Committee of Experts on the Transport of Dangerous Goods and on the Globally Harmonized System of Classification and Labelling of Chemicals

Sub-Committee of Experts on the Transport of Dangerous Goods

Explosives and related matters: tests and criteria for flash compositions

Revised proposals on US- and HSL Flash Composition Tests (ST/SG/AC.10/C.3/2014/72)

Figure A7.10

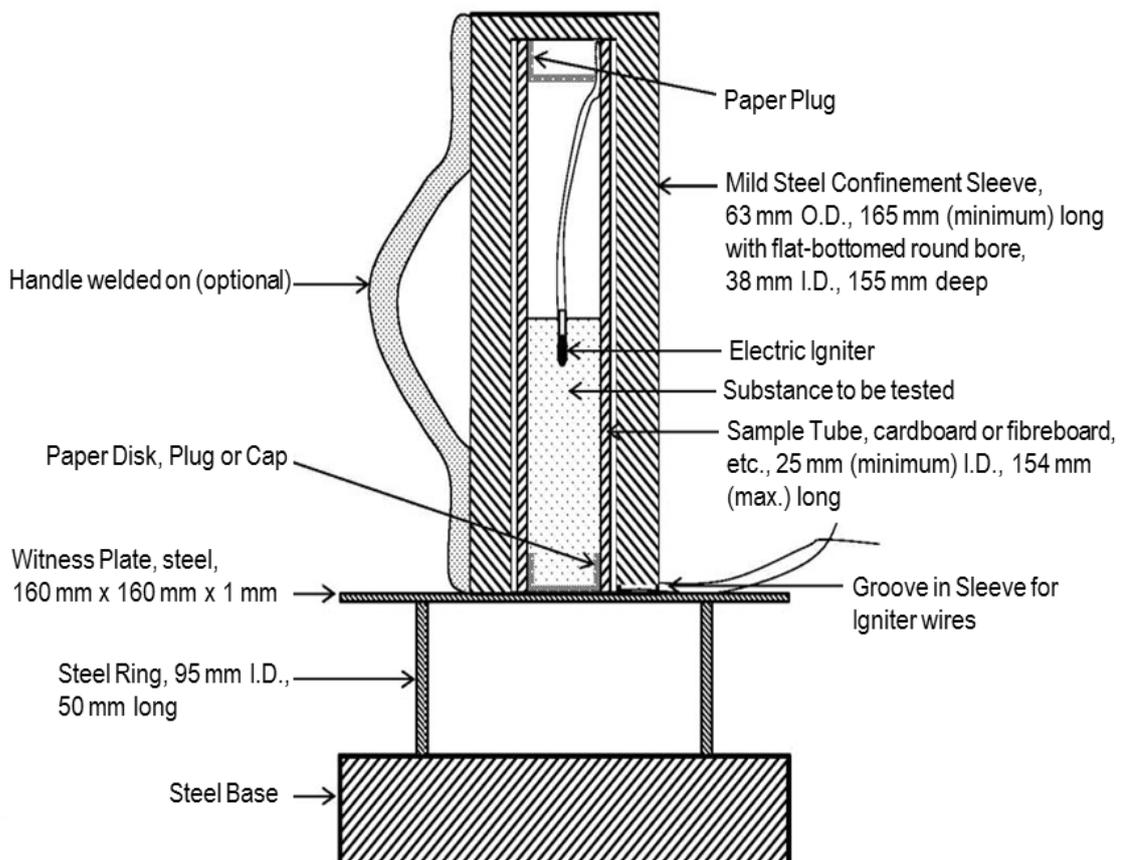
A cardboard or fibreboard sample tube with a minimum inside diameter of 25 mm and a maximum height of 154 ~~150~~ mm with a maximum wall thickness of 3.8 mm, closed at the base with a thin cardboard or paperboard disk, plug or cap just sufficient to retain the sample;

A 1.0 mm thick 160 × 160 mm steel witness plate consisting of steel conforming to specification S235JR (EN10025) or ST37-2 (DIN17100) or SPCC (JIS G 3141) or equivalent having a stretch limit (or rupture strength) of 185-355 N/mm², an ultimate tensile strength of 336-379 N/mm² and a percentage elongation after fracture of 26-46% Steel ST37 or Steel S235JR having a density of 7850 Kg/m³, a stretch limit of 185-355 N/mm², an ultimate strength of 340 N/mm² and a break limit of 26%, or equivalent;

A mild steel confinement sleeve (weighing approximately 3 kg) having an outside diameter of 63 mm and a minimum length of 165 mm with a flat-bottomed round bore whose interior dimensions for diameter and depth are 38 mm and 155 mm, respectively, and which is bored from a solid billet approximately 1 mm deeper than the overall sample tube length and having an inside diameter of 38 mm, an outside diameter of 63 mm and a height of 165 mm with a notch or groove cut into one radius of the open end sufficient to allow the igniter lead wires to pass through (the steel sleeve might be provided with a rugged steel handle for easier handling);

- (a) In any trial the witness plate is torn, perforated, pierced or penetrated; or;
- (b) The average of the maximum depths of indented ~~depth of the indentations from the 1.0 mm thick steel witness plates~~ from all three trials exceeds 15 mm.
